The Commission has issued the enclosed Amendment Nos. 53, 53 and 50 for License Nos. DPR-38, DPR-47 and DPR-55 for the Oconee Nuclear Station, Unit Nos. 1, 2 and 3. These amendments are in response to your application dated November 9, 1977.

These amendments revise the Technical Specifications to allow operation of Oconee Unit 1 Cycle 4 at 100% full power with a flux tilt of 6.03% in an unrodded mode.

ATTACHMENT TO LICENSE AMENDMENT NOS. 53, 53AND 50
FACILITY OPERATING LICENSE NOS. DPR-38, DPR-47 AND DPR-55
DOCKET NOS. 50-269, 50-270 AND 50-287

SAFETY EVALUATION BY THE OFFICE OF NUCLEAR REACTOR REGULATION

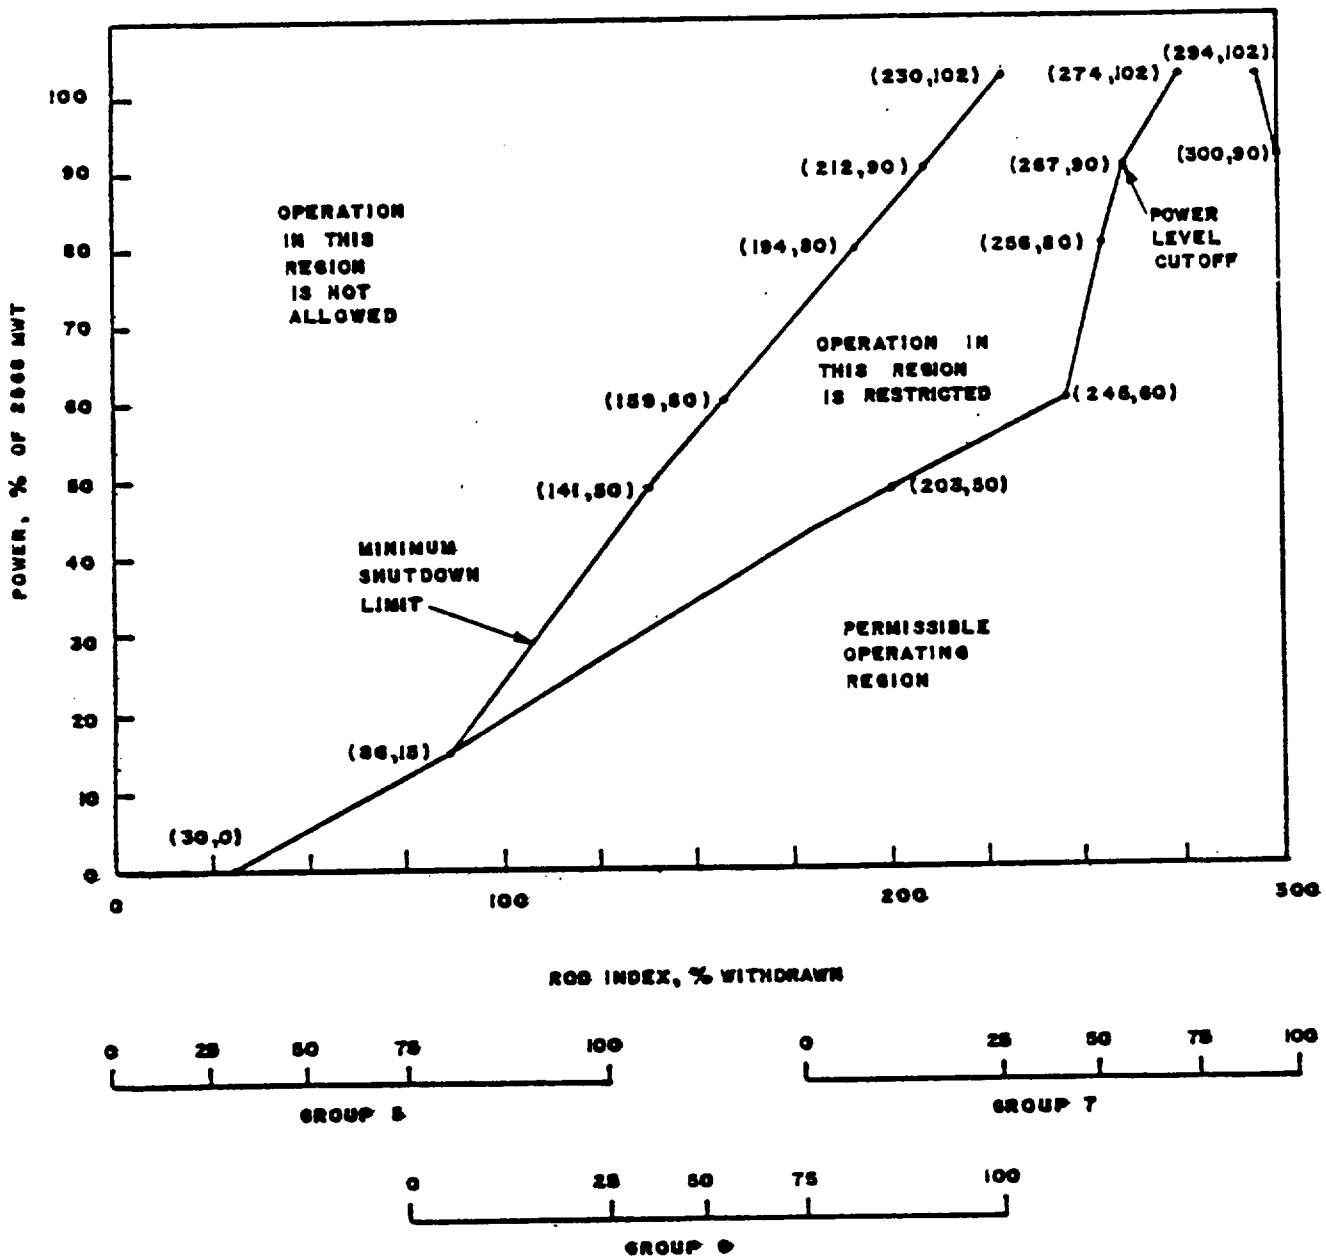
- c. Position limits are specified for regulating and axial power shaping control rods. Except for physics tests or exercising control rods, the regulating control rod insertion/withdrawal limits are specified on figures 3.5.2-1A1, (Unit 1); 3.5.2-1B1, 3.5.2-1B2 and 3.5.2-1B3 (Unit 2); 3.5.2-1C1, 3.5.2-1C2 and 3.5.2-1C3 (Unit 3) for four pump operation, and on figures 3.5.2-2A1, (Unit 1); 3.5.2-2B1, 3.5.2-2B2 and 3.5.2-2B3 (Unit 2); 3.5.2-2C1, 3.5.2-2C2 and 3.5.2-2C3 (Unit 3) for two or three

pump operation. Also, excepting physics tests or exercising control rods, the axial power shaping control rod insertion/withdrawal limits are specified on figures 3.5.2-4A1,

Figure 3.5.2-1A1

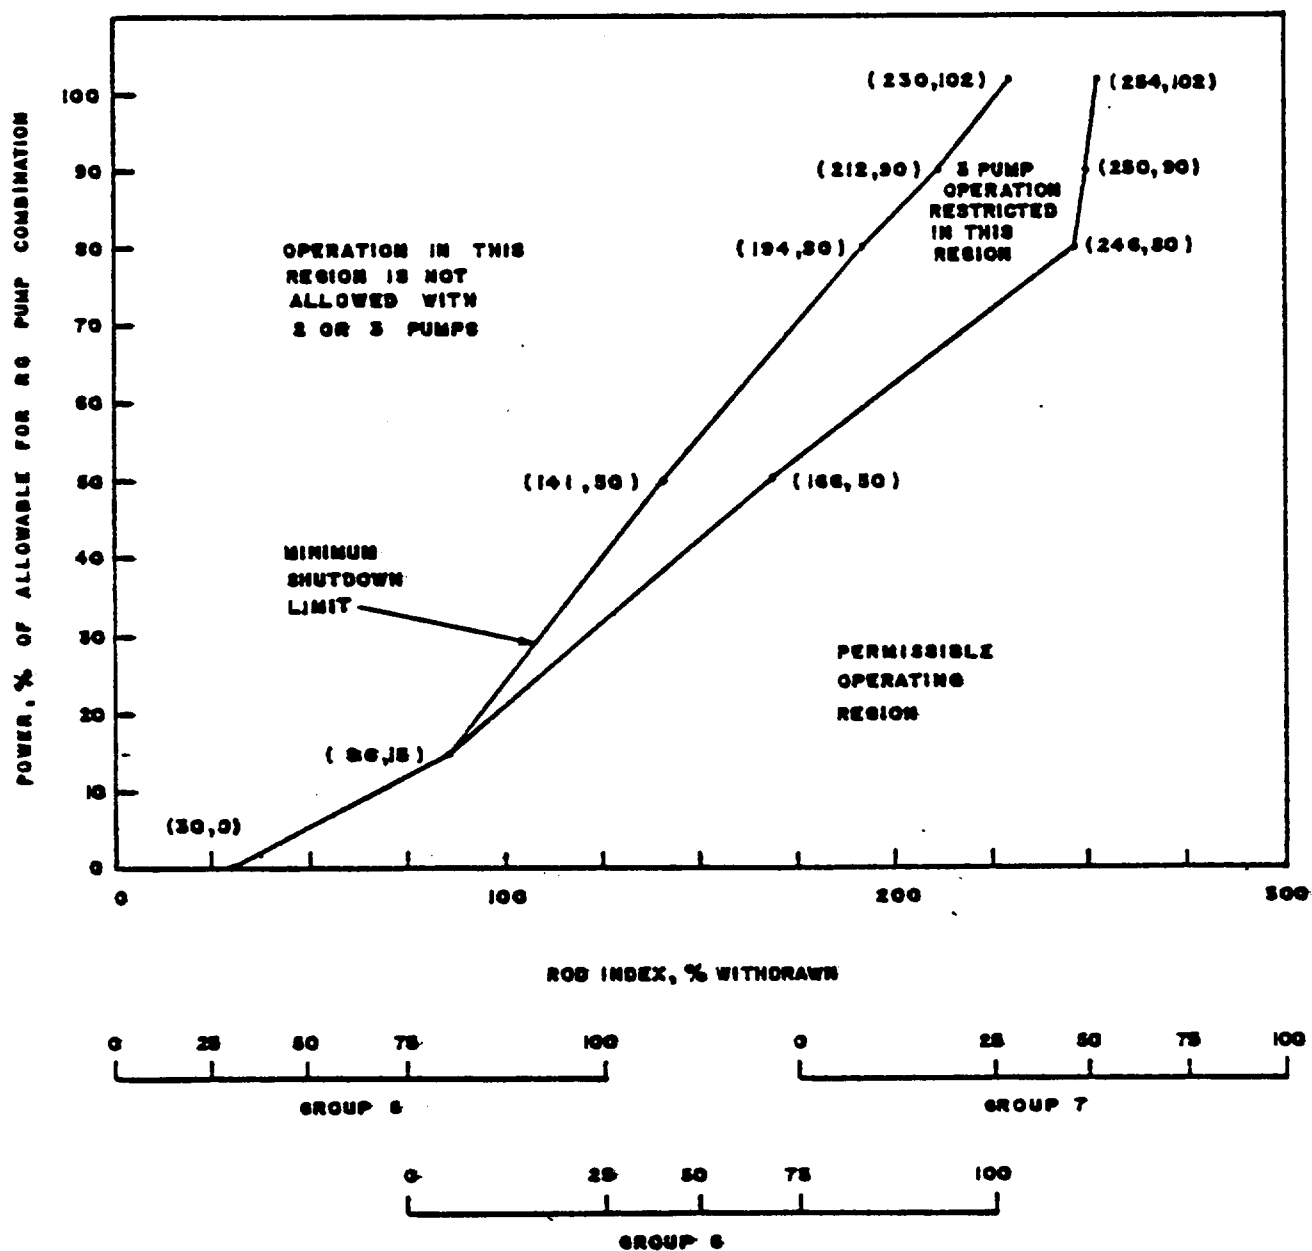
ROD INDEX IS THE PERCENTAGE SUM OF THE WITHDRAWAL OF GROUPS 5, 6 AND 7

OCONEE 1 CYCLE 4 ROD POSITION
LIMITS FOR FOUR PUMP OPERATION
FROM 0 TO 100 (+10) EFPD
